Re: Project No. P-14227-003 Request for Additional Studies

I previously submitted a letter on behalf of my client, EHOFF II Lakeside, LLC, (“Lakeside”) regarding the May 31, 2017, Notification of Intent to File License Application (“NOI”) for the Lake Elsinore Advanced Pumped Storage Project (“Project”), filed by Nevada Hydro Corp. That letter expressed Lakeside’s extensive concerns with the proposed Project’s potential impacts to Lakeside’s private property and with Nevada Hydro’s request to short-cut the standard licensing pre-application process. Extensive changes have occurred to the physical and social environment in Riverside County since Nevada Hydro first submitted an application thirteen years ago in 2004. Thus, Lakeside was surprised when FERC granted Nevada Hydro’s request to waive the normal pre-application requirements, especially given the objections of numerous landowners and interested parties.

Figure G-1: (2 of 24) Lake Elishore Advanced Pumped Storage Route Map
 Source: The Nevada Hydro Company

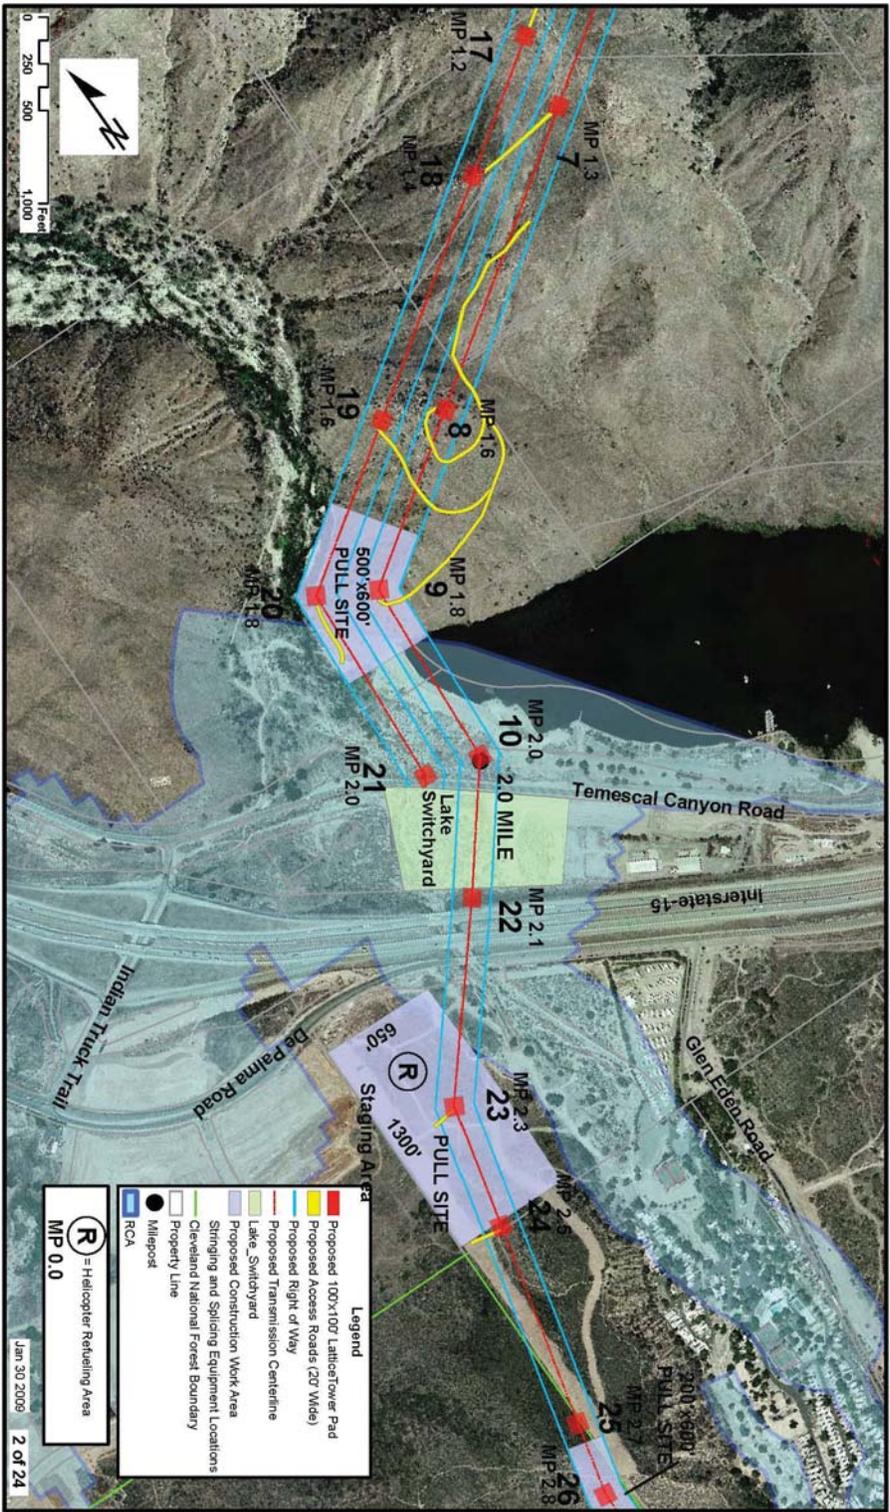
As noted in Lakeside’s prior comment letter, dated August 17, 2017, Lakeside is particularly impacted by the proposed LEAPS project and will be a necessary stakeholder in the license application process. Lakeside owns ±500 acres of property adjacent to Corona Lake (aka Lee Lake), and has already completed substantial portions of the entitlement process for a 410-unit residential development, which will be clustered around Corona Lake and located adjacent to Temescal Canyon Road. (See Attachment A [Overview of Lakeside Residential Development].) The proposed LEAPS transmission lines cross directly through Lakeside’s property and residential development area, including placement of tower pads. (Attachment B [FLA Exhibit

G, p. G-9, Figure G-1 (2 of 24)].) Lakeside is concerned that Nevada Hydro has not reached out to Lakeside regarding this proposed alignment, and that Nevada Hydro has not fully considered its proposed impacts to Lakeside's residential project.
